From: David Sagstad <david.sagstad@devplanning.co.uk>
Sent: 29 November 2021 14:39
To: Claudia Currie
Cc: Matthew Phillips; Jennifer Wagstaff; Nick Bateman
Subject: RE: Nine Acres School - Residual Highways Queries, Formal Response

Subject: Nine Acres School - Residual Highways Queries, Formal Response

Existing Safety Record

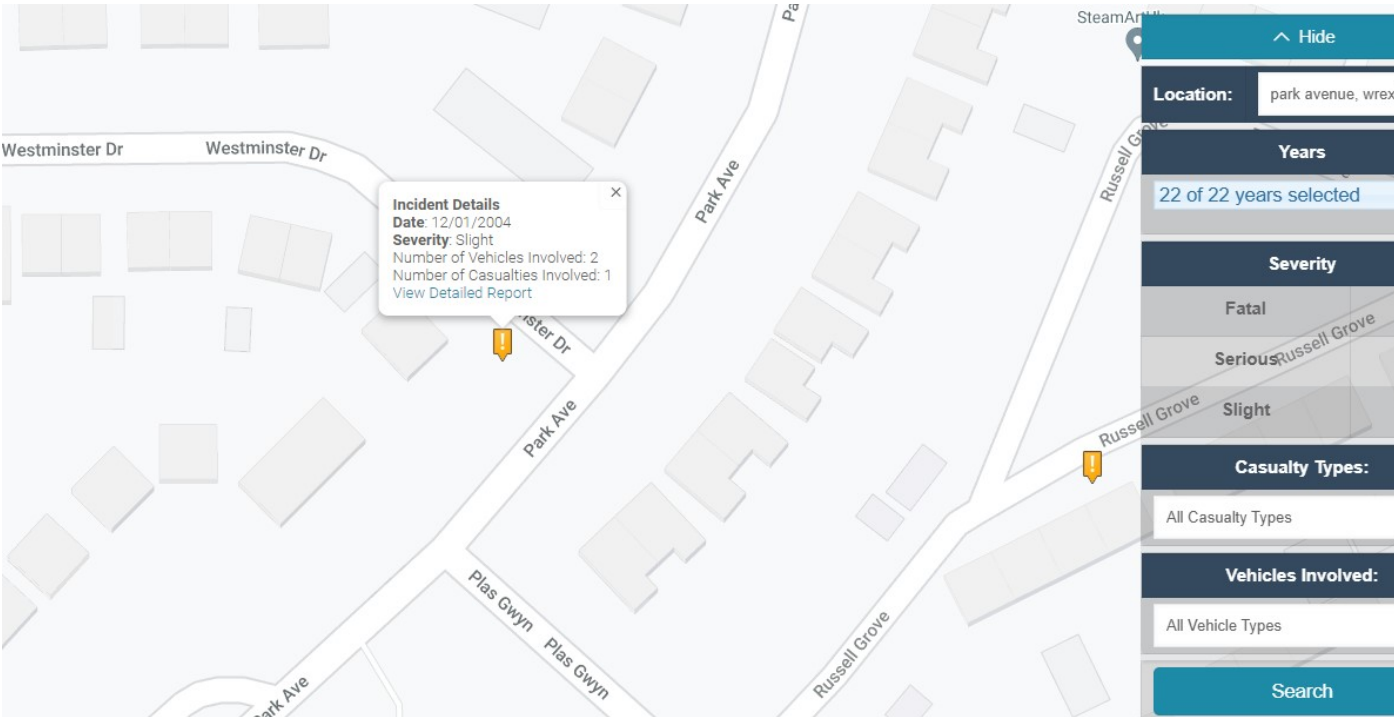
For the situation where the junction is utilised, it is important to firstly consider the accident records at the junction. We have utilised the national Crashmap database for this and summarise the findings below.

By way of background, in the last 22 year’s of data for the junction, there has been one recorded slight accident. That occurred in 2004, with no other accidents in the 17 years since then. That is to say that despite the trees, every single vehicle that has used the junction in 17 years has done so without a reportable accident, i.e. over 6,000 consecutive days with no accidents at all recorded.

For the only accident that did occur I attach the accident report. The report states that the accident was slight and occurred between two cars, both turning left. The driver of the first car appears to be significantly under age and, therefore, would not have had a licence – the driver was in the band 11 to 15. The other driver was in the age band 16 to 20, so may/ may not have been of legal age. In either event, at least one driver did not have a licence. The accident is not one that appears to relate to the trees, rather the experience/ legal status of the driver.

There is no material accident history at the junction:
